SAFETY RECALL

SR22-86

EMERGENCY LIGHTS SYSTEM (ELS)- SENSOR ORIENTATION INSPECTION 9700 (B13R)

Figure 9: sensor with axes decal

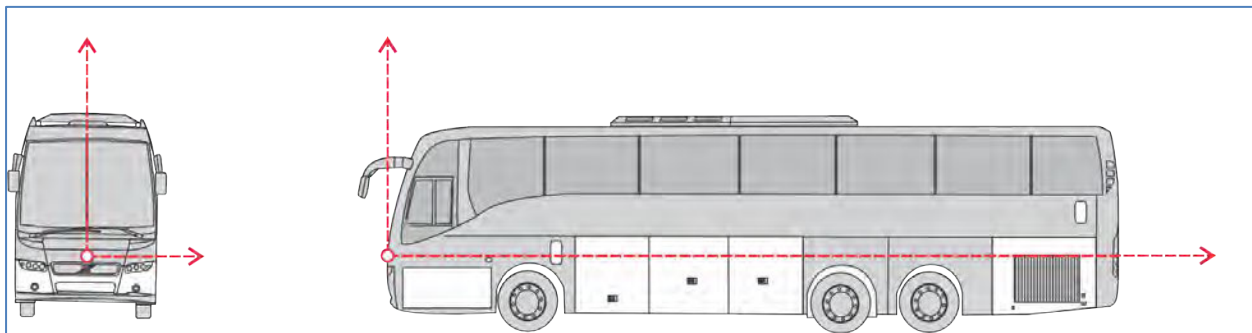
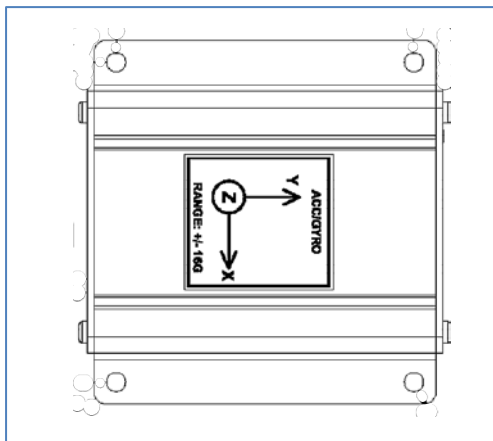
- 1) Turn the engine off.
- 2) Open the service lid for each of the four (4) sensors.
- 3) Check for proper orientation of the sensors. Confirm the axes on the sensor decal line up with the vehicle axes.

The sensors just need to be mounted so that the X, Y, and Z axes on the decal line up with the vehicle axes. It does not matter if the X points to front or back of the bus, the top or bottom of the bus, or to either side of the bus. Just line up the sensor so that it lines up with one of the vehicle axes. The Y and Z should also point to one of them.

- 4) If sensor axes are lined up with the vehicle axes. No corrective measures are required. This ends the bulletin.

Figure 10

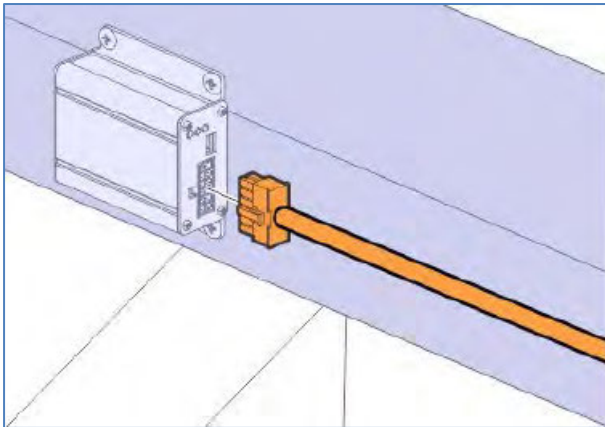
- 1) Remove the key.
- 2) Wait at least 30 seconds.
- 3) Turn off the battery switch.
- 4) Remove the negative terminal from the battery.
- 5) Correct the orientation the sensor where required.
- 6) Disconnect the sensor.

Figure 11

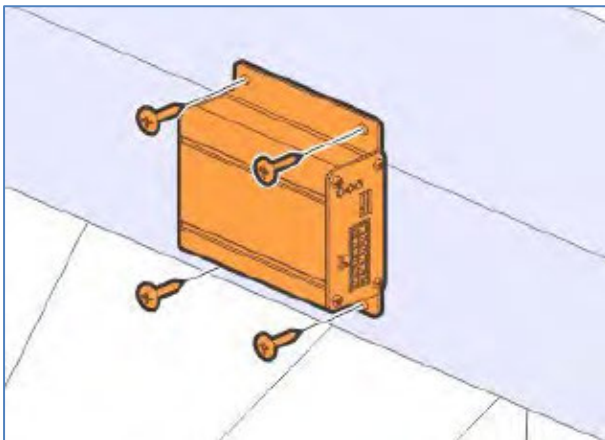
- 7) Remove the sensor

Figure 12

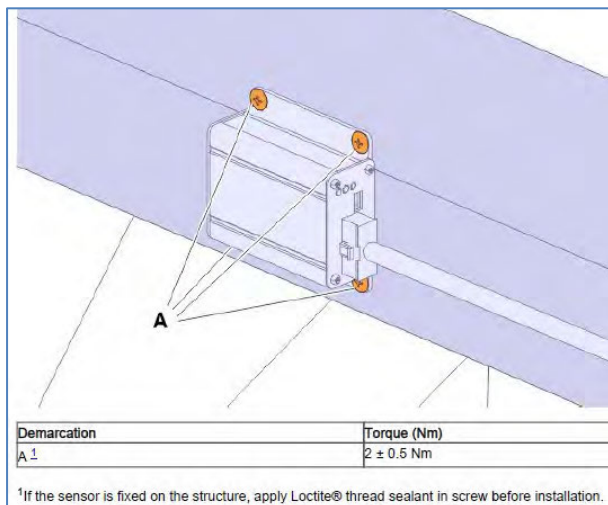
- 8) Reinstall the sensor in proper orientation and connect. Screws P/N 70368861.
